Re: Request for Comment (RFC): *Advanced Driver Assistance Systems Draft Research Test Procedures*, NHTSA Docket No. 2019-0102, 84 Fed. Reg. 64405 (November 21, 2019)

The Alliance for Automotive Innovation (Auto Innovators)¹ appreciates this opportunity to provide input to the National Highway Traffic Safety Administration (NHTSA) regarding the Advanced Driver Assistance Systems (ADAS) Draft Research Test Procedures Request for Comment (RFC).

Figure 8-6: CCFtap scenario paths definition

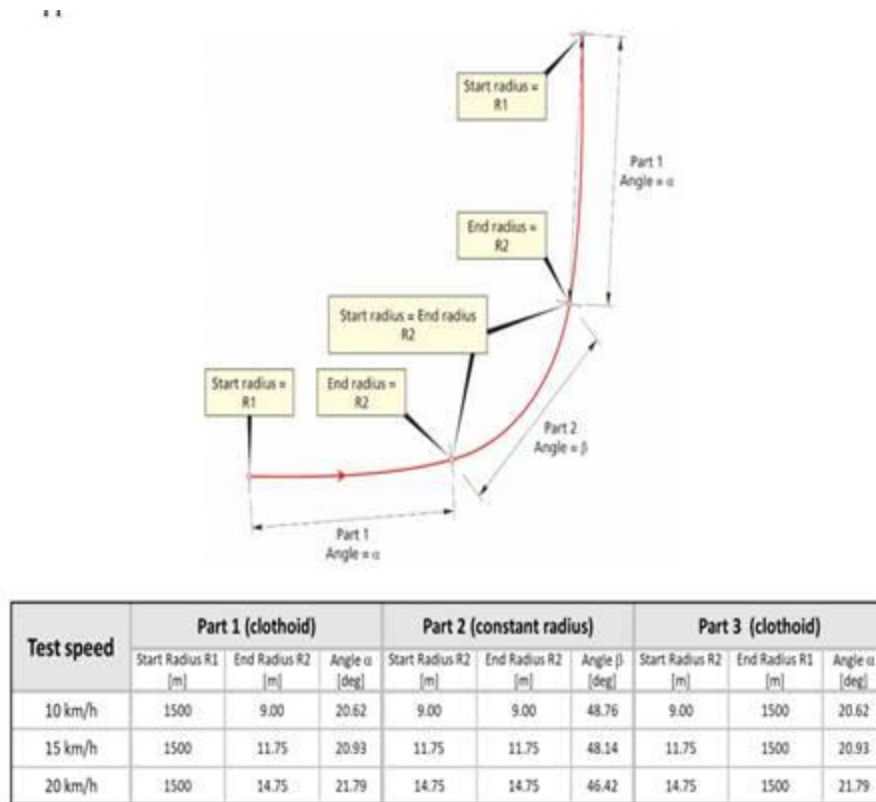
NHTSA is using a single radius to define their left turn paths for the POV and the SV as a single radius (page 83 and 86 of the TJA procedures, left image). The justification for this is to simplify the programming of the driving robot. Euro NCAP (right image) uses a modified left turn that is a combination of clothoids and a radius. We understand that this would increase programming complexity, but the goal is to simulate/test real-world driving scenarios and a single radius does not justify that.

Additionally, for L0 and L1 system testing, NHTSA should harmonize with EuroNCAP and define car-to-car lateral distance as well as minimize tolerance in order to minimize variability in testing and results.

Figure 1: Diagram of PTM and SV approach in S1f scenario

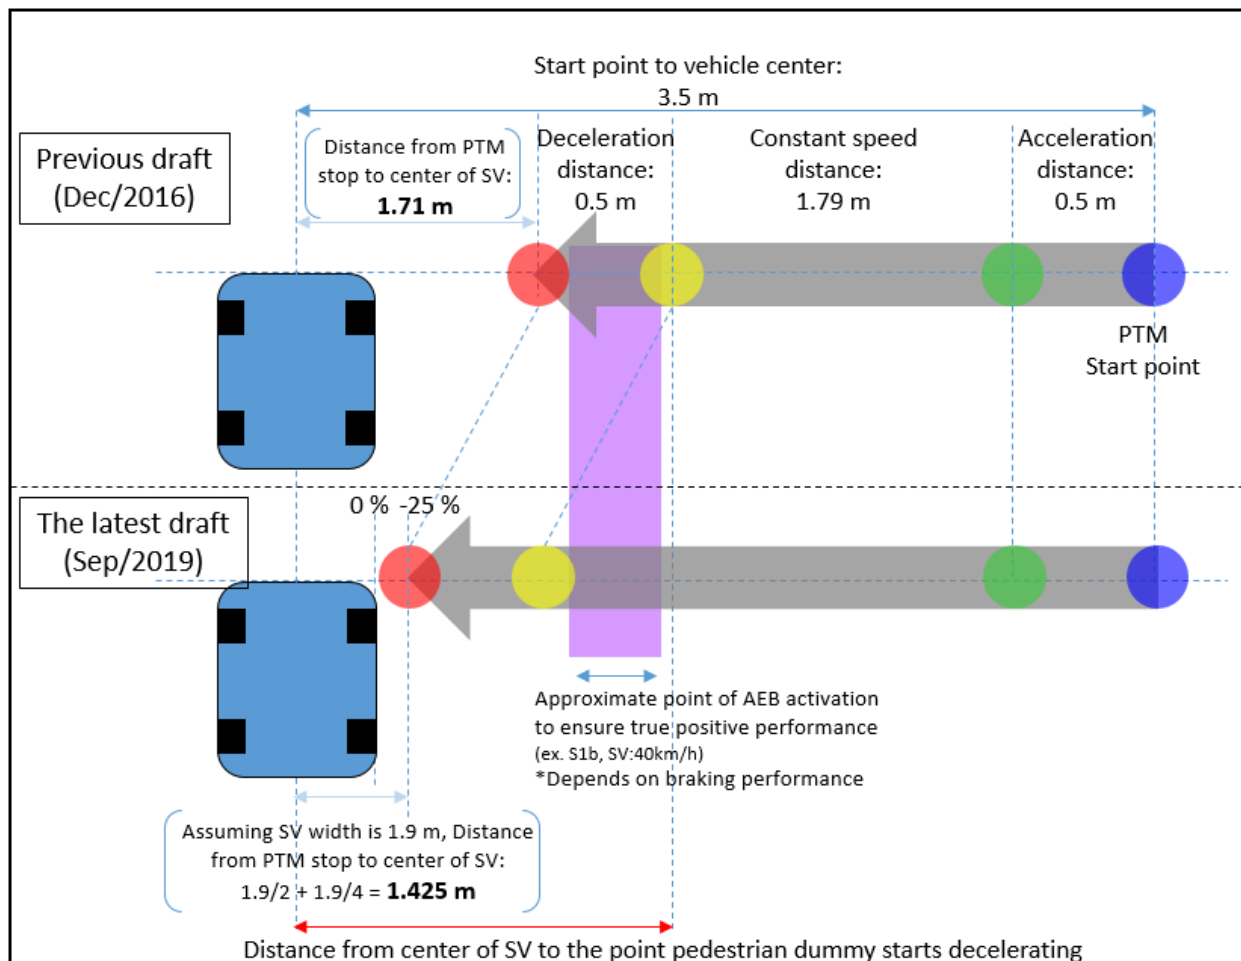
With current PAEB sensing technology and braking performance, the AEB will need to activate at a time that substantially overlaps with the dummy deceleration timing (see Figure 1). In other words, when the system determines that the pedestrian has completely stopped, the AEB system has already activated the brakes to avoid the collision. If the test procedure intends to evaluate a false-positive scenario (i.e. the SV is expected to not come to a stop) – which we do not recommend including – it is expected that the performance of PAEB would need to be reduced in true positive conditions. Auto Innovators members design PAEB systems by balancing the performance of true positive/false positive scenarios both in the real world and on the test course.

Overall, Auto Innovators recommend eliminating false positive tests for all ADAS test requirements because they would likely result in manufacturers designing their systems to the test rather than incentivizing real world false positive countermeasures. However, if NHTSA chooses to conduct this test, we suggest the following: In real world situations where a pedestrian walks this close to a vehicle, a human driver should (and would likely) stop to avoid a seemingly imminent collision. For the reasons

above, we propose that the S1f and S1g scenario should be modified to reflect more realistic situations. We recommend modifying S1f such that the pedestrian stops at a more realistic distance, such as that proposed in the prior PAEB test procedure draft. For S1g, the PTM should “clear the vehicle’s path” with greater margin (distance) to represent a more realistic case of a walking pedestrian with the SV not expected to stop.

Figure 2: Pedestrian Target Mannequin Leg

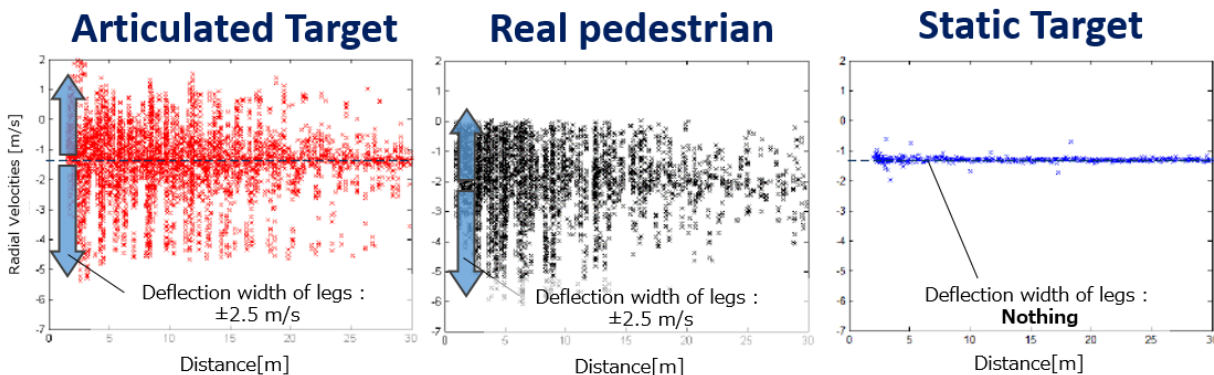
NHTSA's testing requires the use of a posable PTM with non-articulating legs that do not move relative to itself while testing. Today's advanced PAEB systems continue to make significant improvements in detection accuracy and recognition speed while minimizing false-positives. Non-articulating leg PTMs are more challenging for PAEB systems to detect while also encouraging systems to detect objects that are not representative of real pedestrians. Figure 1 provides an example of how Articulated leg PTMs more accurately represent a real pedestrian, when viewed by a PAEB sensor system. Such effects are also likely to occur for camera systems as well.

For these reasons, we strongly urge that the agency allow the use of the Articulated Leg PTM for evaluating PAEB systems. Pedestrian crash avoidance, both in this test procedure and in the real world, often present very challenging scenarios where the pedestrian is obstructed and/or provide very short reveal times. In order for PAEB systems to effectively address pedestrian injuries in the real world, it is critical that PAEB sensors recognize pedestrians quickly and accurately. Therefore, it is critical that PTMs used to evaluate this technology be as representative of a real pedestrian as possible. The allowance of an articulated leg PTM is absolutely necessary to ensure that PAEB performance can be maximized while also minimizing false-positive activations (e.g. with roadside objects). We also note that only the articulated leg PTM will be allowed in Euro NCAP from 2018 and in J-NCAP from 2020.

- Each graph shows radar measurements of radial velocities on target/pedestrian objects
- The speed of articulating target, real pedestrian and the static target was 5kph
- The articulated target shows similar Doppler spread to that of a real pedestrian
